**FINDINGS OF FACT and FINAL ORDER  
TYPE I DESIGN REVIEW**

<b>DATE:</b>	March 19, 2026
<b>FILE NO.:</b>	26-009 DR_TREE - MHAC Pickle Ball Courts
<b>APPLICATION:</b>	Type I – Design Review
<b>APPLICANT:</b>	Mt. Hood Athletic Club (MHAC)
<b>PROJECT NAME:</b>	MHAC –Pickle Ball Courts
<b>OWNER:</b>	Paul Reed
<b>ZONING:</b>	C-2 (General Commercial)
<b>MAP AND TAX LOT:</b>	4E14BA, Tax Lot 1100
<b>STAFF CONTACT:</b>	Patrick Depa, Senior Planner

**Figure 5**

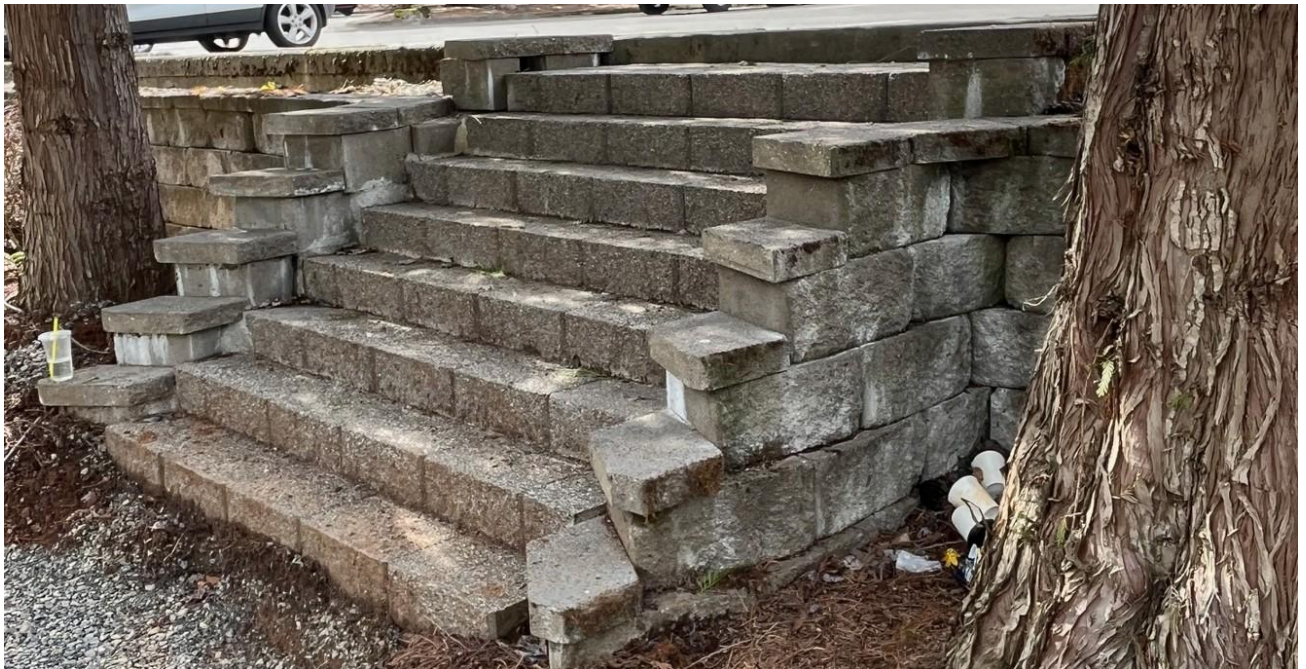
**Finding 14:** The pickleball courts are proposed to be built in an existing landscape area that is roughly four (4) to six (6) feet lower than the adjacent parking area. There is an existing concrete stairwell that navigates the change in elevation. However, **the current stairwell is not up to Oregon’s Specialty Building Code (OSBC) and shall be removed, reformed, and replaced with stairs that meet the required dimensions (Figure 5). This includes the required handrails as described in OSBC. The stairs shall terminate with a minimum five foot by eight-foot (5’ x 8’) cement landing before you can enter the pickleball court area for ADA accessibility.**

- A. **The applicant shall apply for and receive approval for all necessary building, mechanical, plumbing, and electrical permits prior to any construction. Contact the Building Division regarding submission requirements. The plans shall include the following:**
1. Details on new stairs and handrails that meet the required dimensions as described in Oregon's Specialty Building Code (OSBC).
  2. Details on a cement landing that is a minimum five foot by eight-foot (5' x 8') in an area prior to entering the pickleball court area.

**Figure 6**

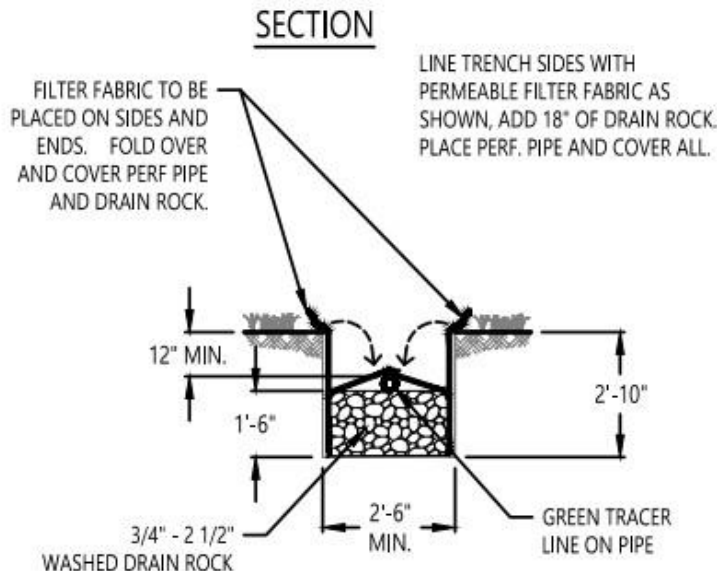
**Finding 19:** Additional stormwater detention is required for the two new pickleball courts. MHAC is proposing a similar design to what was used on the first court that was built. It is a smaller-sized detention facility called a trench drain design and is proposed to be situated along the east side of the two courts. The drain is designed with perforated pipe and pea gravel to restrict or detain the stormwater, releasing it at a slower rate (see Figure 6). During heavy rain events, the system is designed to overflow directly into an existing stormwater rain garden/detention area south of the courts.

Prior to the installation of the pickleball courts, **the applicant shall call the City for an inspection to confirm that the detention facility is sized according to the Portland Stormwater Management Manual at adjusted rainfall rates for Sandy. No work shall be done near the City’s stormwater system or any connections made to the City system without a permit from the Public Works Department.**
